ADDENDUM NO. 1

ADDISON AIRPORT CONSTRUCT WEST TAXIWAY AND CONNECTORS WITH DRAINAGE IMPROVEMENTS (SOUTH SEGMENT)

BID NO.: 98-04 TxDOT NO.: 9842 ADDSN

December 18, 1997

ADDISON AIRPORT **ADDENDUM NO. 1 PARTIAL DRAWING NO. 22**

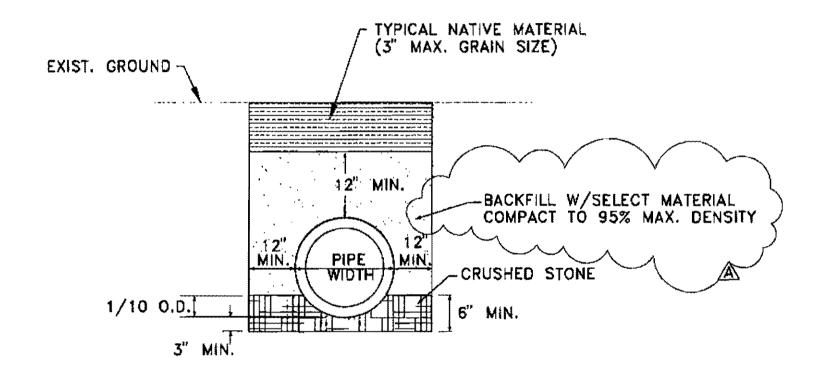
C. Drawing No. 22

REVISE the Embedment Detail for Storm Sewer Detail No. 1 to add compaction requirements as per the attached Partial Drawing No. 22.

A ADDED COMPACTION REQUIREMENTS 12/18/97

ADDISON AIRPORT ADDENDUM NO. 1 PARTIAL DRAWING NO. 22

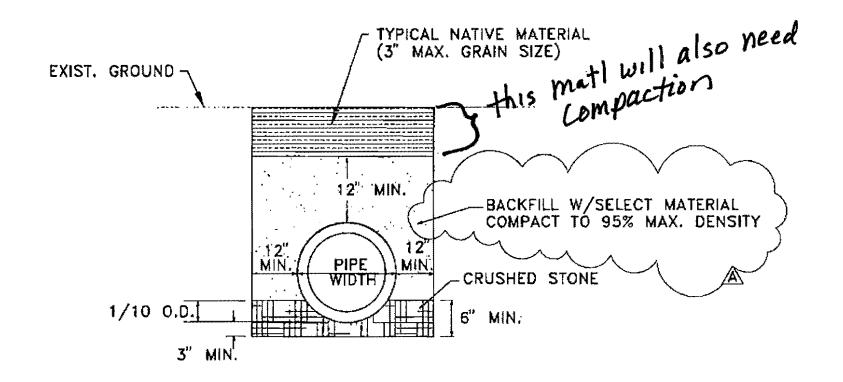
Oddendum does not address comment on drainage - will be addressed in. The next addendum

▲ ADDED COMPACTION REQUIREMENTS 12/18/97
